P 537306
 A 517336

**ON-SITE SEWAGE DISPOSAL SYSTEM
 HOWARD COUNTY HEALTH DEPARTMENT
 BUREAU OF ENVIRONMENTAL HEALTH**

South Cornell Backhoe IS PERMITTED TO INSTALL ALTER
 ADDRESS: 4410 Salem Bottom Rd Westminster MD 21157 PHONE NUMBER: 410-596-3618
 SUBDIVISION: The Warfields II LOT NUMBER: 23
 ADDRESS: 14871 Michele Drive PROPERTY OWNER: NVR Inc.

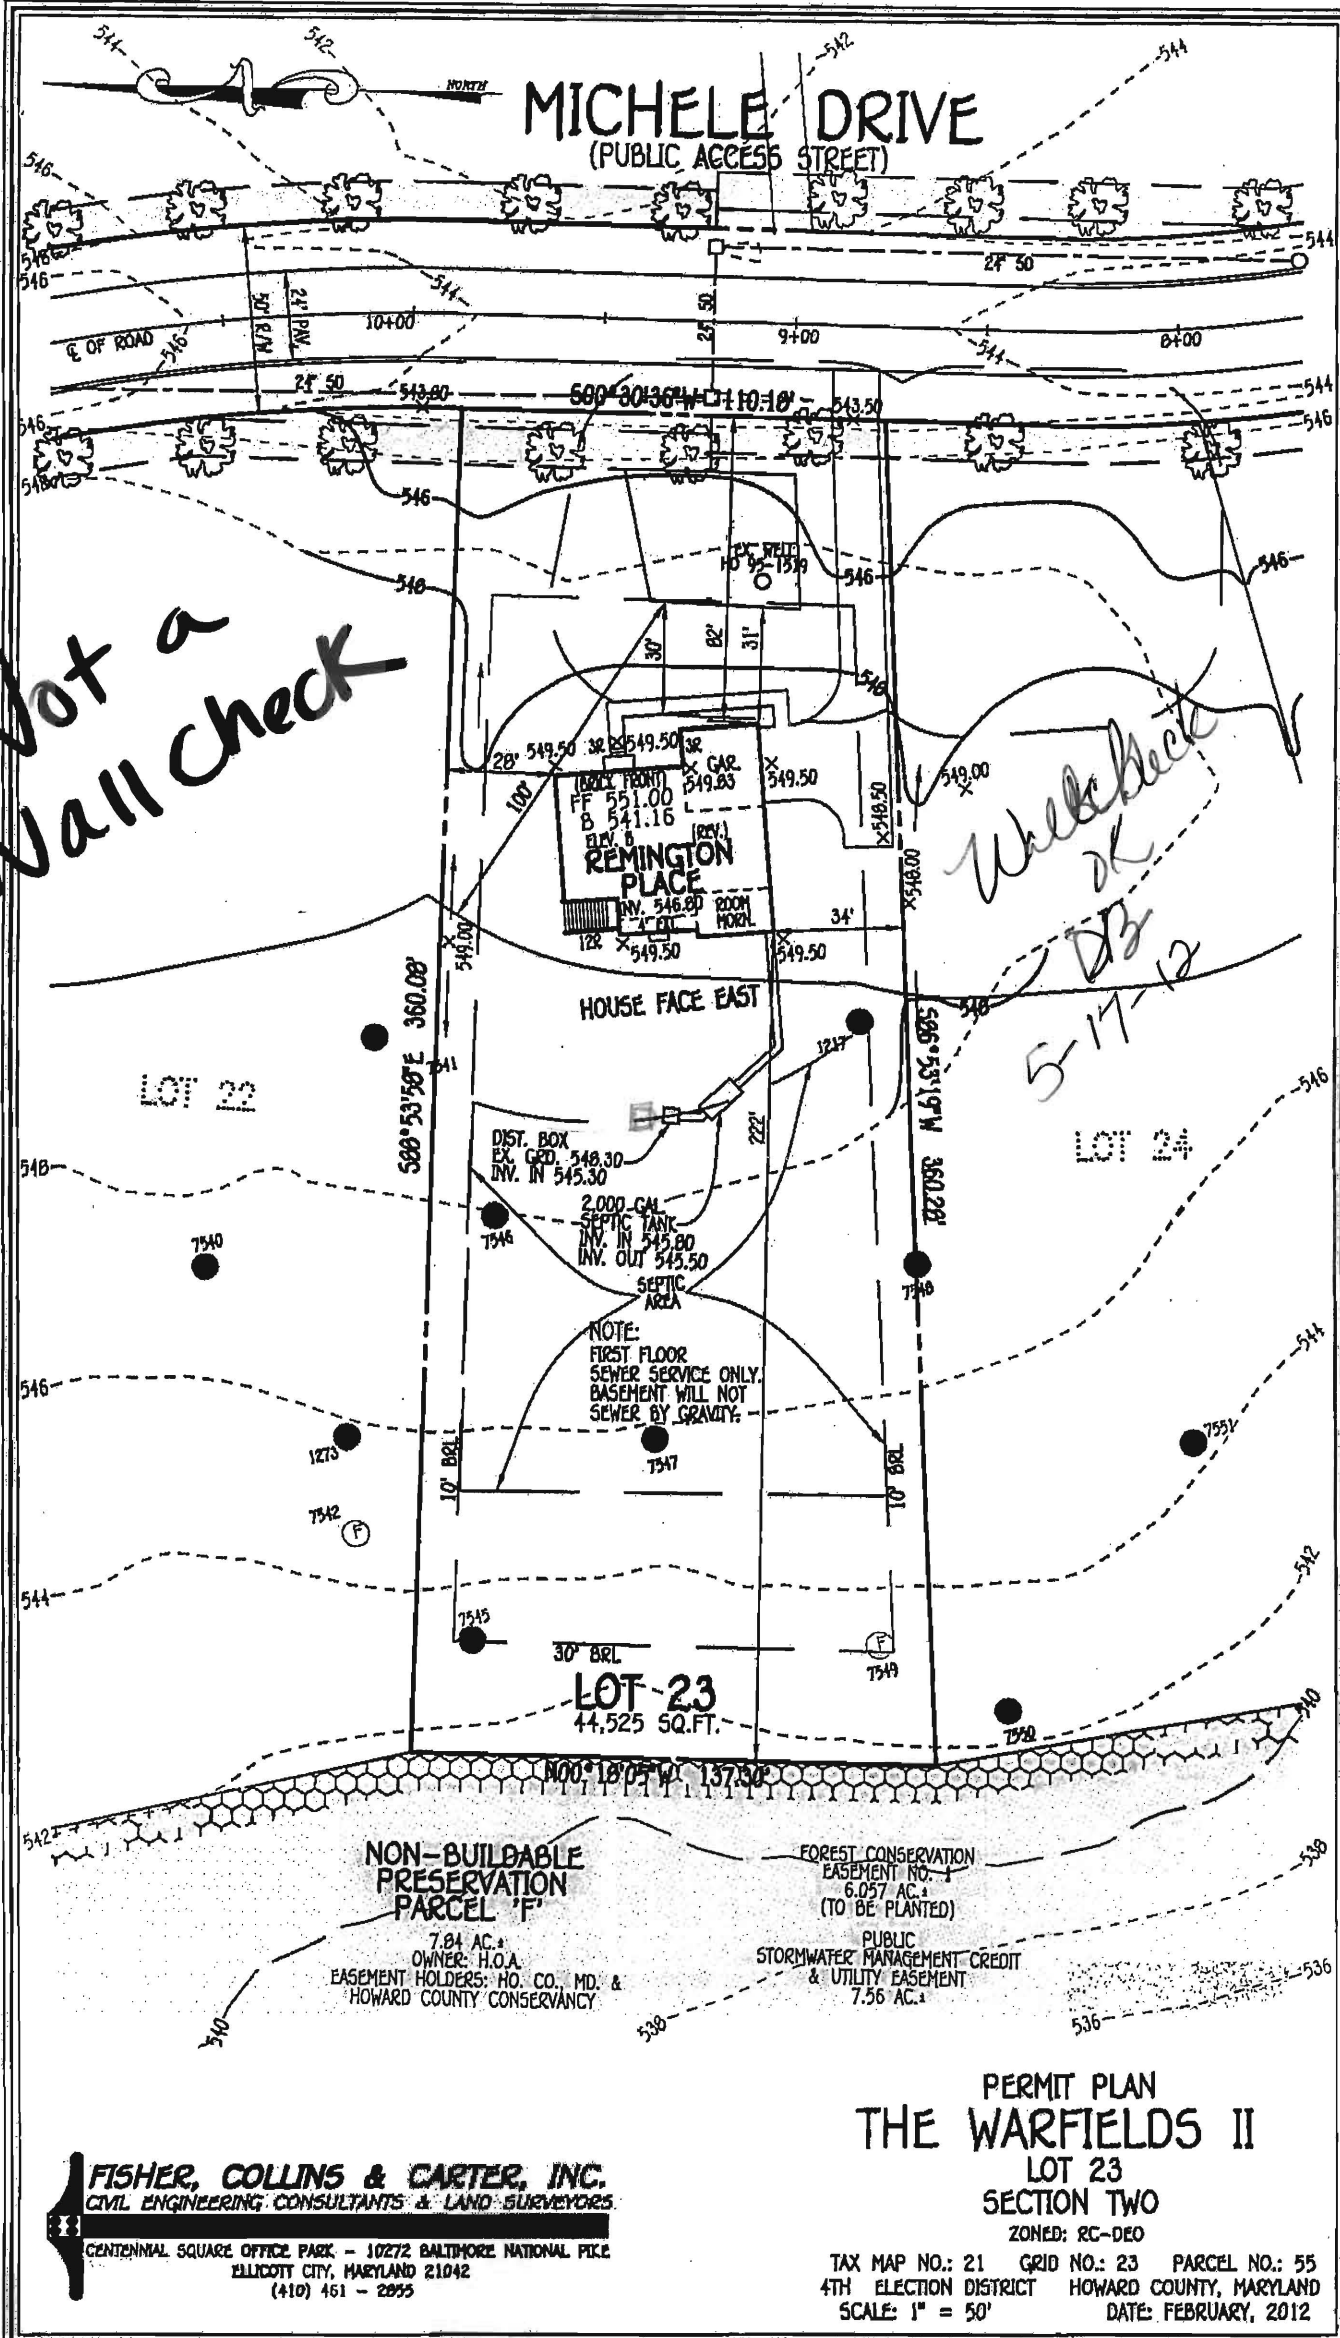
5/30/12 SRA not staked. No layout given. (KW)

6/1/12 Tank set. SRA staked. Contractor not on site. (KW)

6/4/12 Set Dbox top center of SRA. Install 2x 50' trenches in both directions. Keep 10' etc. Specs adjusted as shown.

6/5/12 Top trenches installed. No Dbox or house connection. OK to continue (KW)

6/6/12 Trenches complete. Dbox set. Need SHC (KW)

6/15/2012 Everything covered. House connection made. (B/B)
